Request for Class II Permissive Change

FCC ID:EW780-1920-00

Date: 2020-09-02

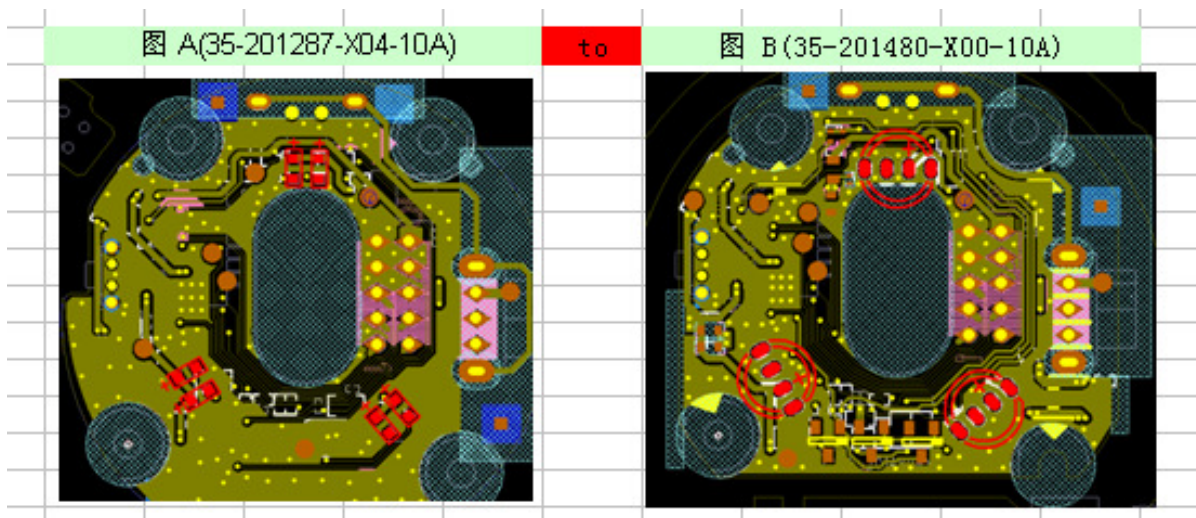
1. Based on original version to change the temperature sensor from outside to inside; See below photo;

2. To change the temperature sensor from outside to inside, The PCB layout of power was updated from 35-201288-004-100 to 35-201480-X00-10B as below

A (35-201287-X04-10A)

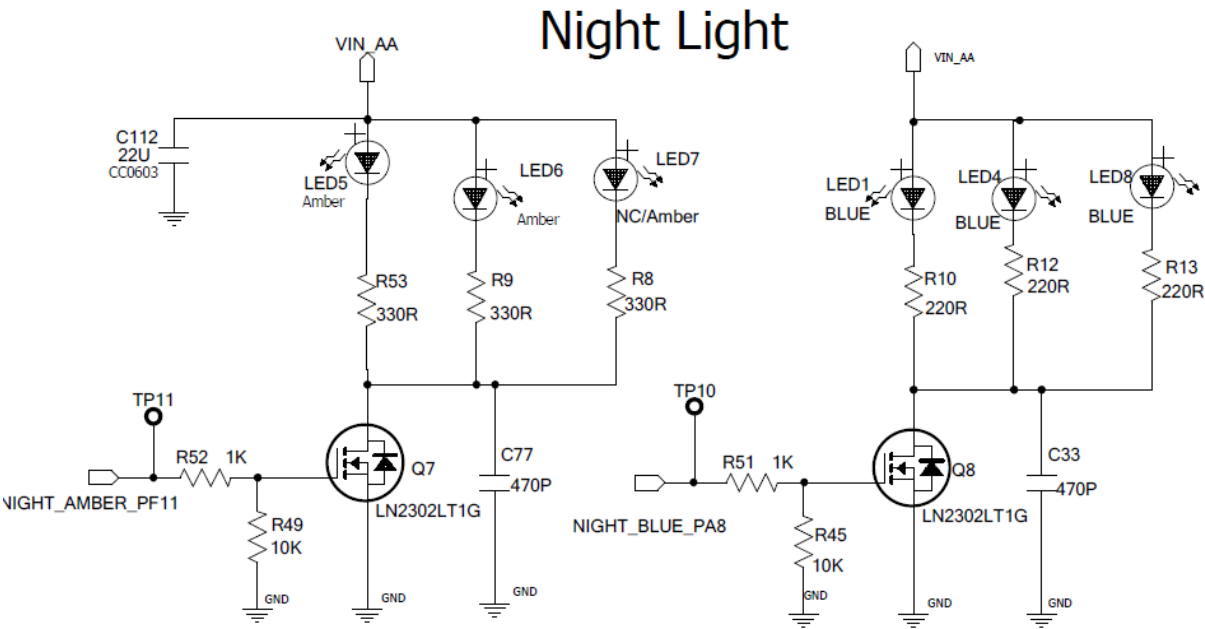
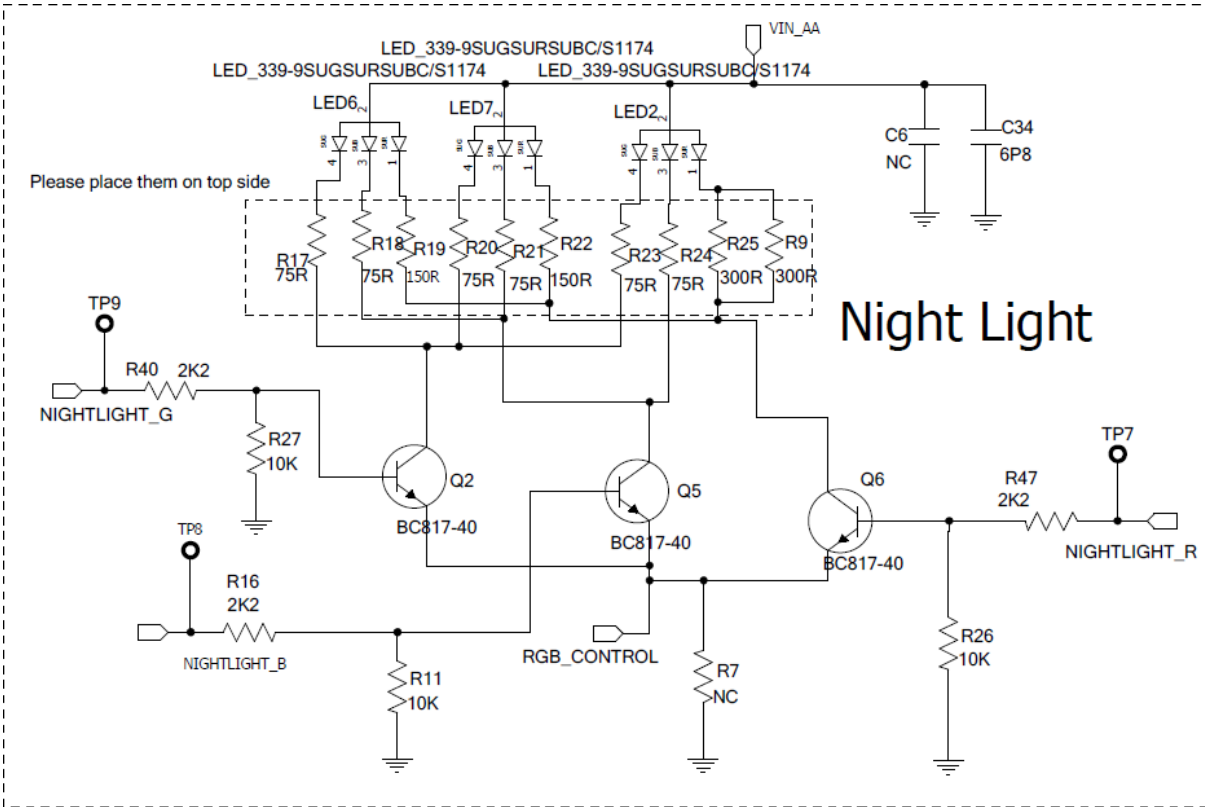
3.The PCB layout of Night Light was changed from surface Mounted technology component to through hole technology component, And the circuit was changed as from A (35-201287-X04-10A to B (35-201480-X00-10A). And the LED component from “19-217/S2C-AM2N2VY/3T(V)_LED5,LED6,LED7 ” and 19-217/G7C-APIQ2B/3T_LED1,LED4,LED8” to “YL5ARGB9UCK22/P17-H,_LED2,LED6,LED7”.

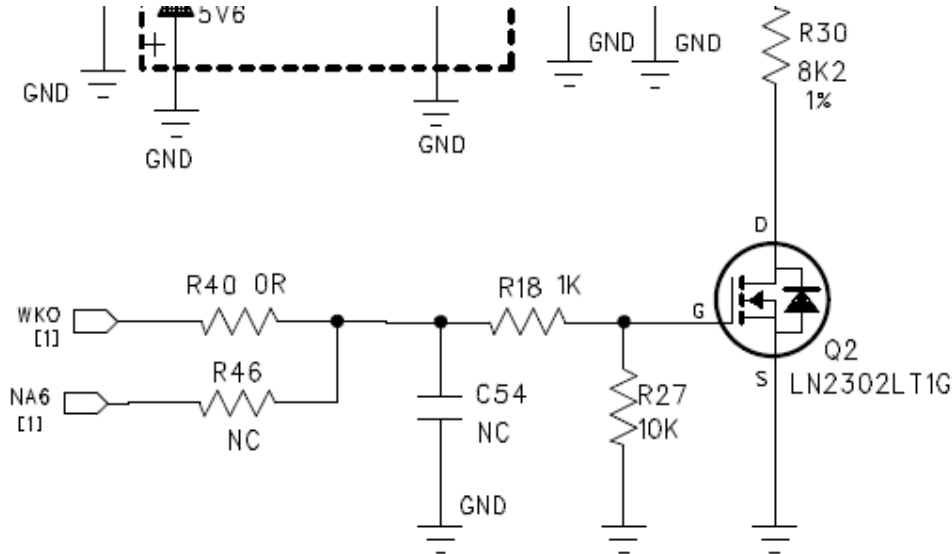
4. To control the Night sensor and Night light LED, the main PCB layout and circuit were updated and newly added parts as below in SCH&PCB (35-201487-001-100):
